April 8, 2011
Project No. 11-03-36

Re: Response to TCEQ Notice of Deficiency Letter Dated March 8, 2011, Trinity Oaks Landfill, Groundwater Monitoring Well System Revision Permit Modification; MSW Permit No. 556, Dallas County, Texas; Tracking No. 14612180; RN100217942/CN601541469

MONITORING WELL LOCATION MAP

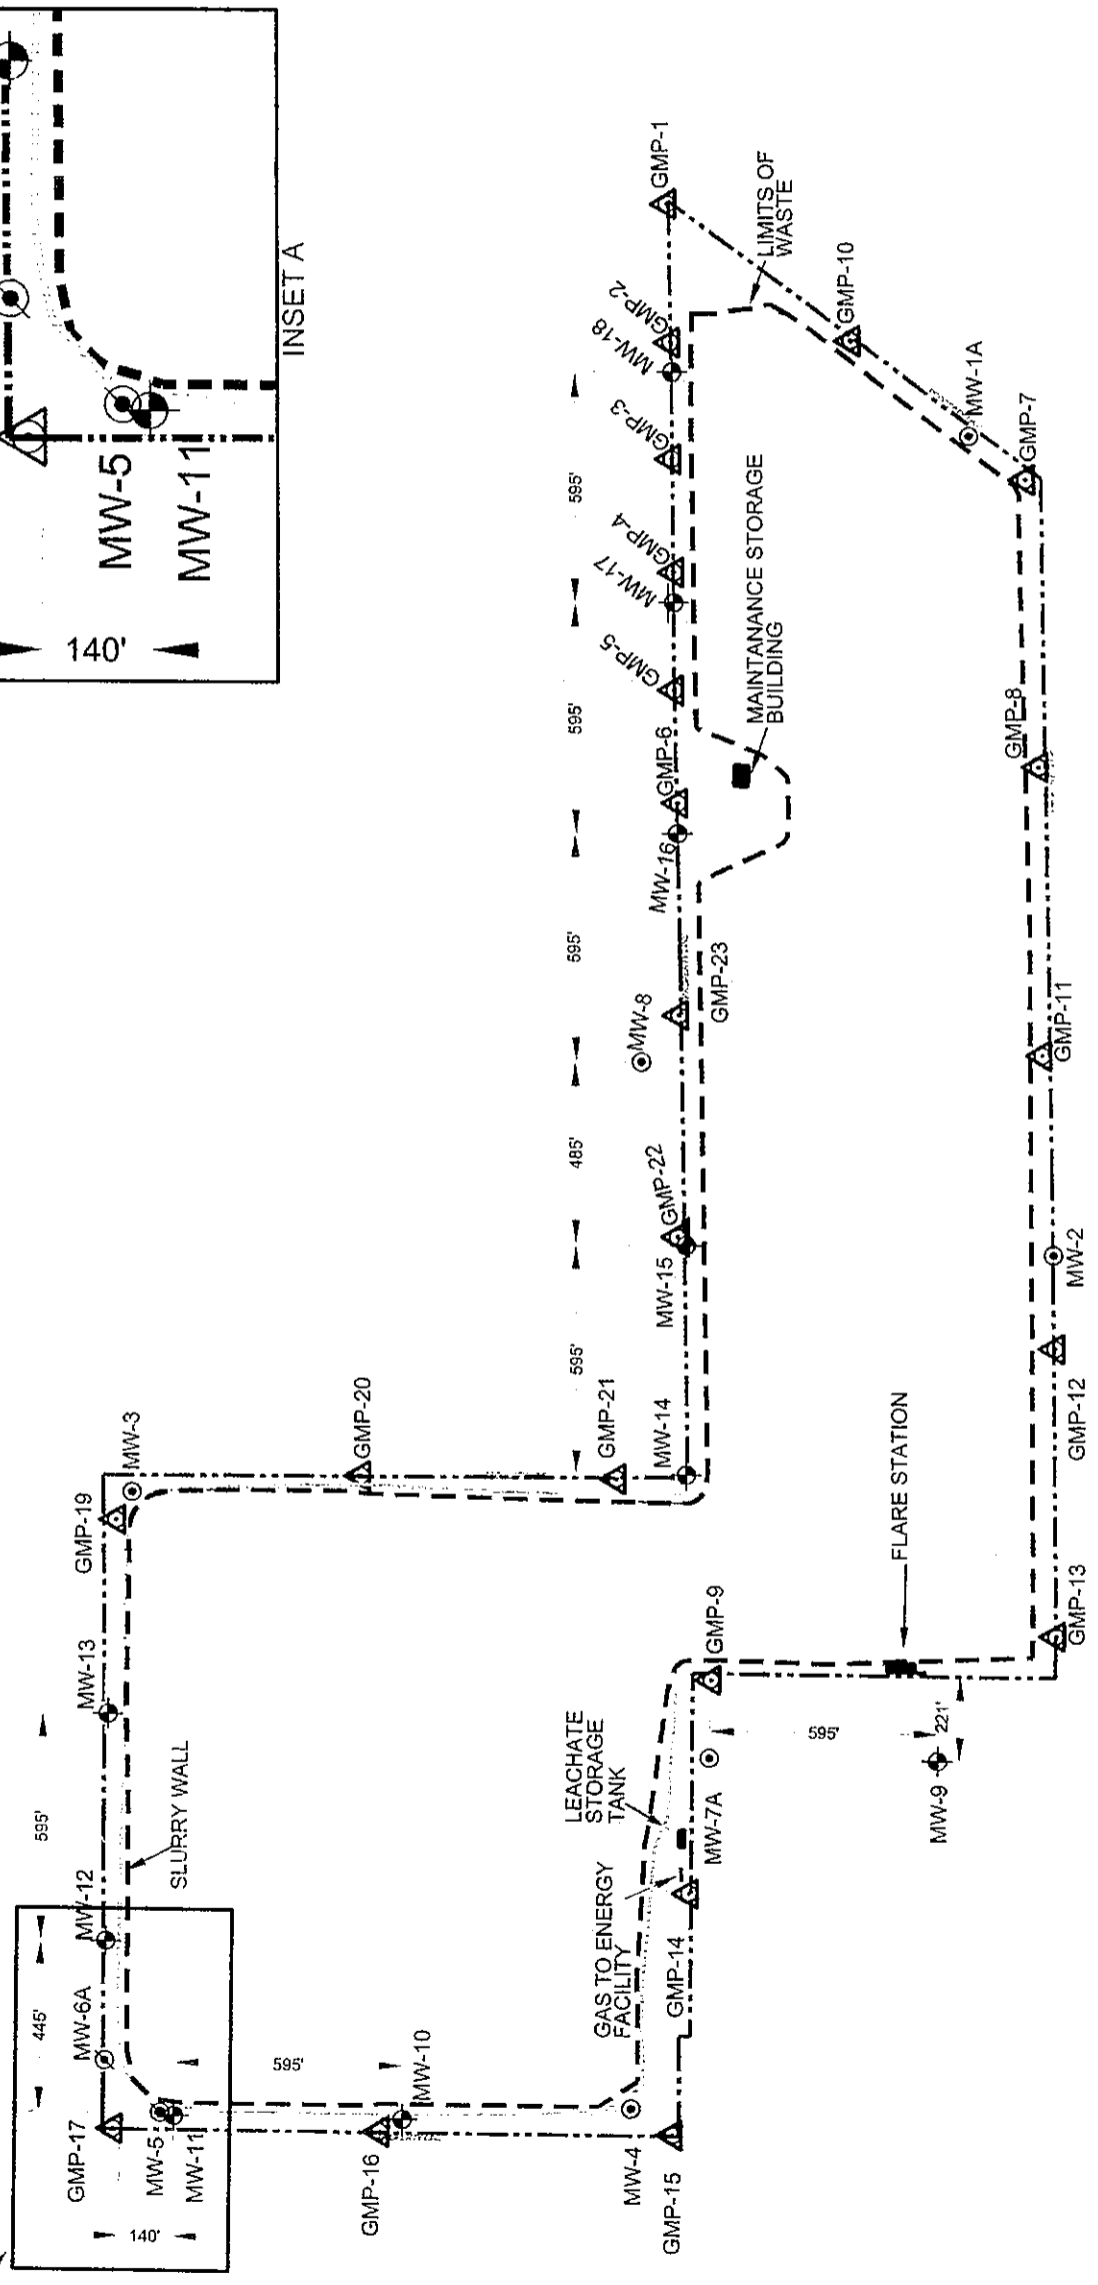
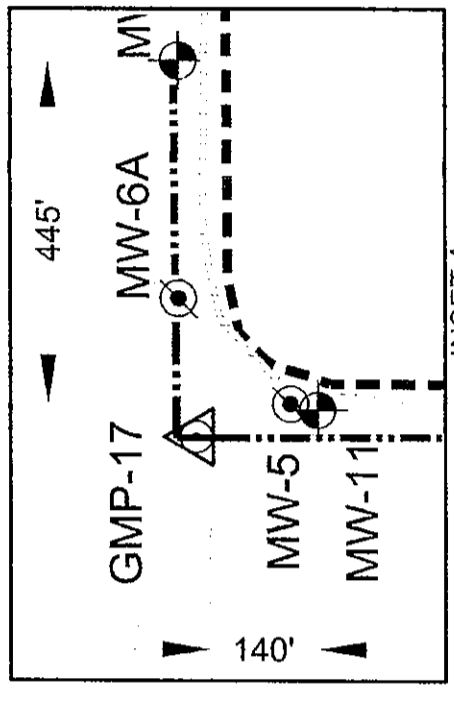
Comment 1: Please clearly verify whether all contents shown in Drawing 5.1 are consistent with the current permit conditions/authorizations (except for the proposed new wells). It was also noticed that Drawing 5.1, Monitoring Well Location Map, was revised to show landfill gas monitoring probes (GMPs) that were not shown in Drawing 5.1 in the original permit modification application. Inclusion of the GMPs has crowded the drawing and degraded the graphic delineations. Please provide a larger scale drawing or revise to improve readability (please ensure that the drawing shows by legends whether or not the GMPs are existing; and if not existing, please revise the application to include necessary discussions about the non-existing GMPs).

Comment 2a: *Please clarify whether the permit boundary depicted in Drawing 5.1 is the currently approved permit boundary and clarify which proposed wells, in addition to the newly proposed MW-9, will be located outside of the permit boundary. Please revise the application to locate all the proposed wells within the permit boundary.*

Comment 2b: *Alternatively, please revise this application at relevant location(s) to include documents to demonstrate that the permittee owns or has long-term control over the property containing the off-site wells. We suggest that areas containing the offsite wells be incorporated as buffer to the current facility boundary or use a perpetual lease and provide documentation to that effect.*

Comment 3: *In consideration with the response to Comment No. 8 and the response to Comment No. 6, please revise the application to extend the point of compliance (POC) to cover the spaces between MW-3 and MW-14, and MW-4 and MW-7A, respectively. Please also place new wells on the POC between MW-3 and MW-14, and MW-4 and MW-7A, respectively (the well spacing shall not exceed 600 feet.)*

Response: All of the contents illustrated on Figure 5.1 are consistent with the current permit conditions/authorizations. The figure was revised, in accordance with Comment 4 contained in a TCEQ letter dated January 21, 2011. In that letter the TCEQ requested that we verify whether the contents shown in Figure 5.1 were consistent with the current permit conditions (except for the proposed new wells). It was further requested that any inconsistent contents be identified/explained/justified or the drawing was to be revised as necessary. The TCEQ also requested that the drawing be revised to show the approved waste footprint.

Figure 5.1 was modified, as requested, to include inconsistent contents (i.e. site features). These include seven (7) surface water let-down structures located on the side slopes of the landfill and 22 gas monitoring probes. Call outs (labels) for other site features previously illustrated but not specifically identified or labeled on the original drawing were also added. Call outs were added for the leachate storage tank, flare station, and maintenance/storage. A newer topographic map for the facility (December 27, 2006) was also used as the base map for Figure 5.1.

Edits have been made to Figure 5.1 to improve its readability, as requested, and a revised version is attached for inclusion into the permit.

Response: Existing wells MW-7A and MW-8 installed in August 1999 and July 1994 respectively, are located outside of the permit boundary illustrated on Figure 5.1. Additionally, proposed well MW-9 is located outside of the permit boundary.

Response: Additional monitor wells located between MW-3 and MW-14 and MW-4 and MW-7A would be redundant. Further, the section of the landfill between MW-3 and proposed well MW-14 does not meet the definition of a POC as stated in 30 TAC 330.3(106), as most of that section is greater than 500 feet from the hydraulically downgradient placement of waste. The portion that is within 500 feet of the downgradient placement of waste will be monitored by the proposed POC defined by wells MW-14 through MW-18 and MW-8. Similarly, the section of the landfill between MW-4 and MW-7A does not meet the definition of a POC as most of that section is also greater than 500 feet from the hydraulically downgradient placement of waste. That portion of the landfill within 500 feet of the downgradient placement of waste will be monitored by the proposed POC defined by wells MW-7A and MW-9. An attached demonstration document is provided in order to demonstrate how the proposed POC designed between MW-7A and MW-9 and proposed wells MW-14 and MW-18 meets the requirements of 30 TAC 330.3(106) and how additional POC segments between MW-4 and MW-7A and MW-3 and proposed well MW-14 are redundant and provide no added benefit to the groundwater monitoring activities at the site.
